Technical Service BULLETIN

Title: **M.I.L. "ON" DTC P0420**
Models: **'03 - '04 Corolla**

REVISSED
EG028-04
ENGINE

TSB REVISION NOTICE:

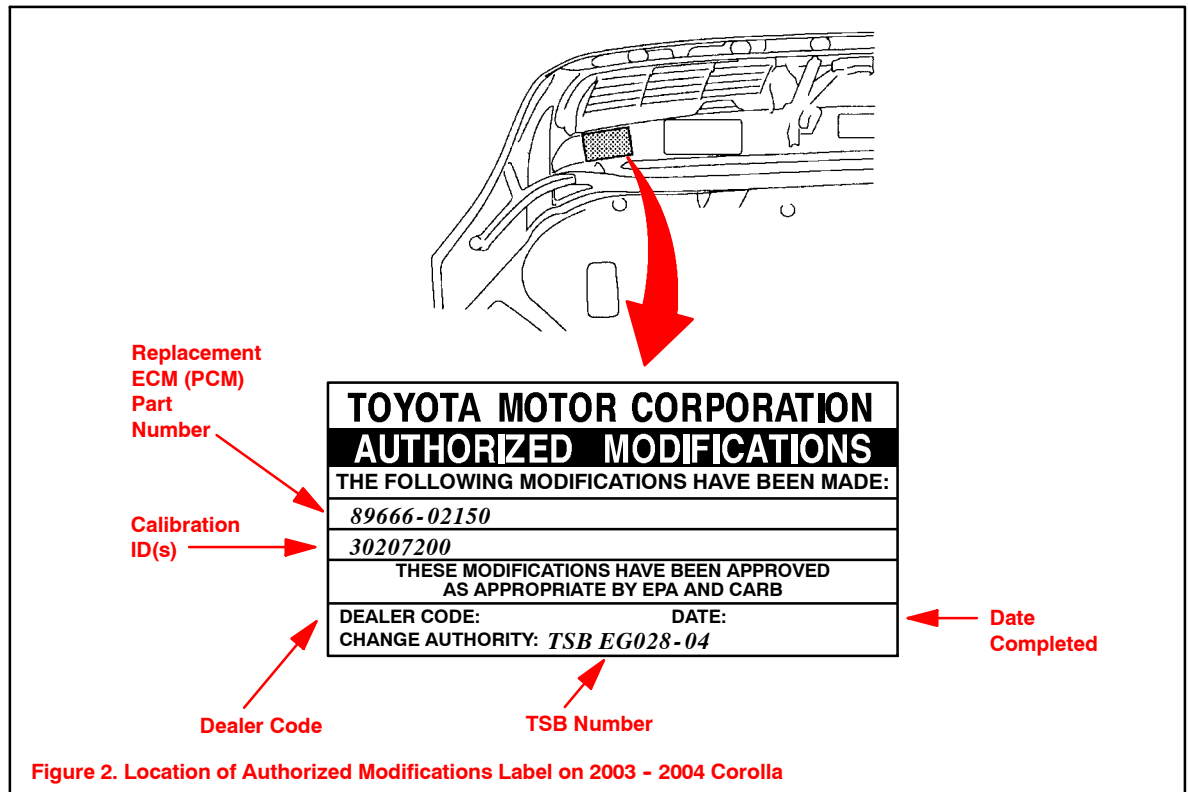
October 8, 2004: Part number for replacement ECM (PCM) in Figure 2 on page 5 has been updated; Reference to section in Technical Information System (TIS) has been updated in "ECM (PCM) Replacement Procedure" on page 5. The previous TSB should be discarded.

7. Enter the following information on the Authorized Modification Label shown below in Figure 2 using a permanent marker.
- ECM (PCM) part number.
 - New ECM (PCM) calibration number.
 - Your dealer code.
 - Reprogramming date.
 - This TSB number.
